ERRATA SHEET

WRIR 86-4358 PLATE 4

HYDROGEOLOGY OF STRATIFIED-DRIFT AQUIFERS AND WATER QUALITY IN THE NASHUA REGIONAL PLANNING COMMISSION AREA
SOUTH-CENTRAL NEW HAMPSHIRE

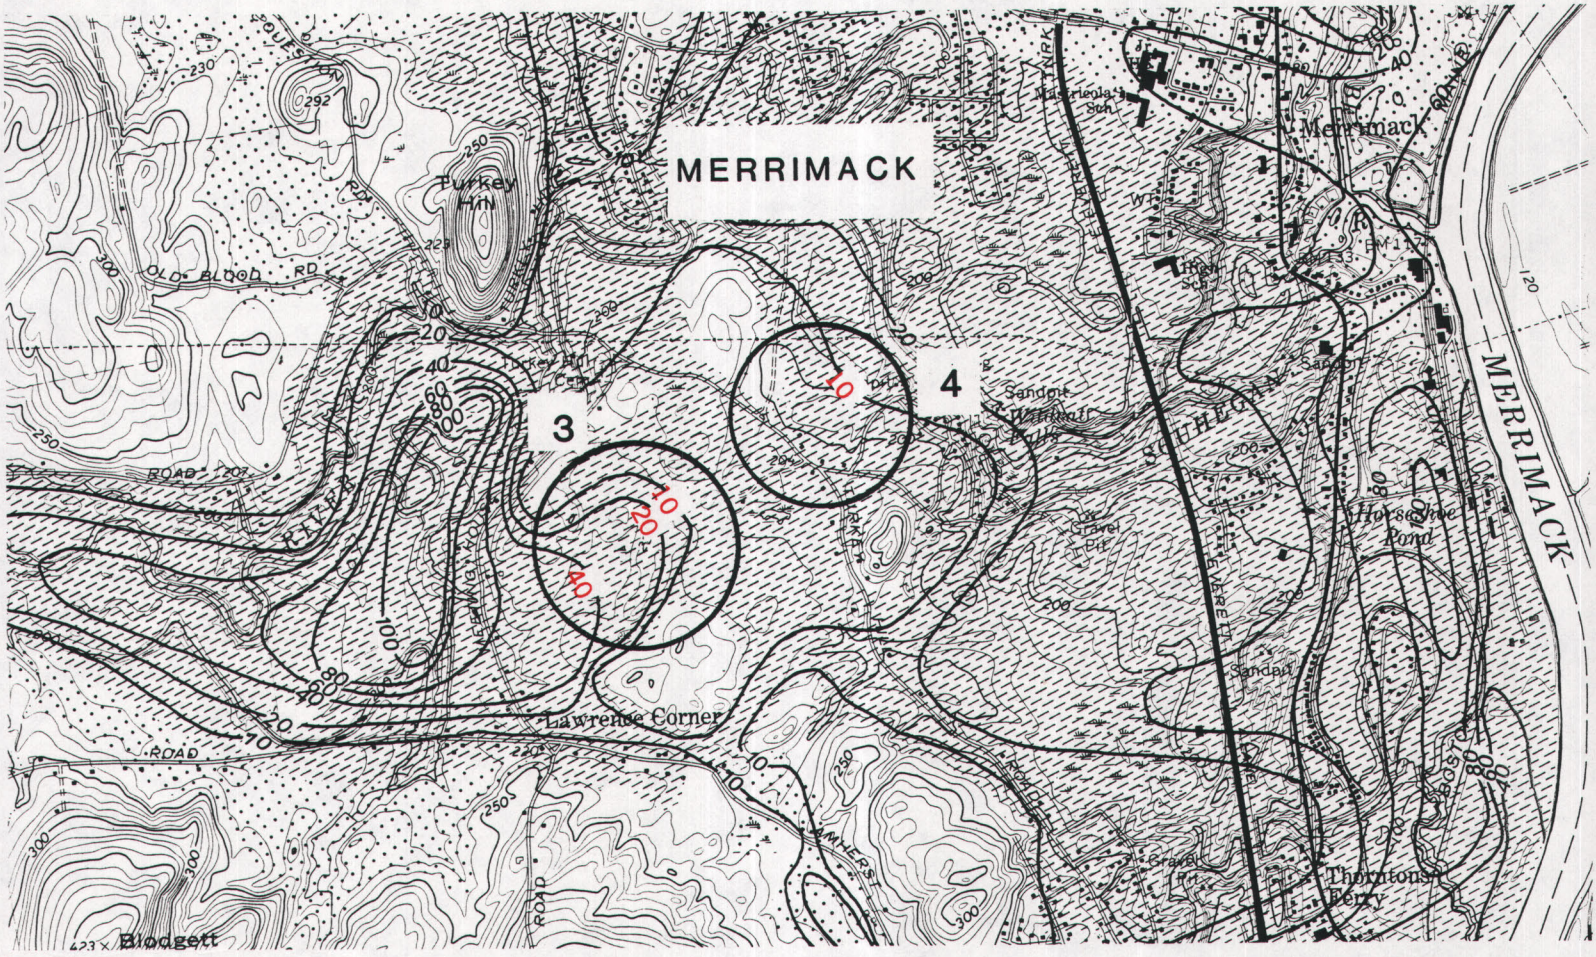
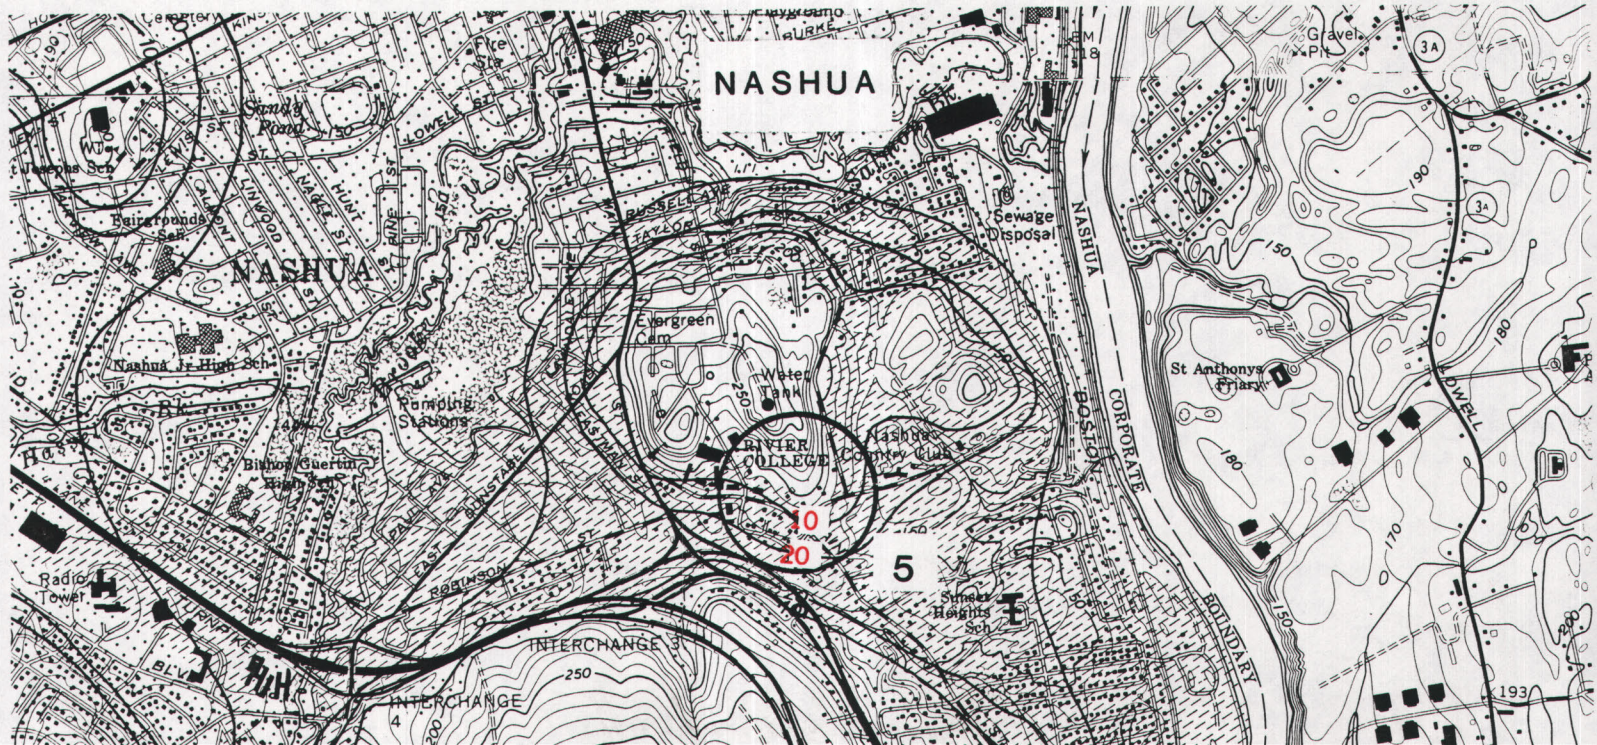
ERROR	TOWN	NEAREST LANDMARK	CORRECTION
3	Merrimack	Lawrence Corner/Souhegan River area	Saturated thickness contours 20, 40, 60, should be 10, 20 40.
4	Merrimack	Lawrence Corner/Souhegan River area	Saturated thickness contour 40 should be 10
5	Nashua	FE Everett Turnpike/Rivier College area	Saturated thickness contours 40, 60, should be 10, 20
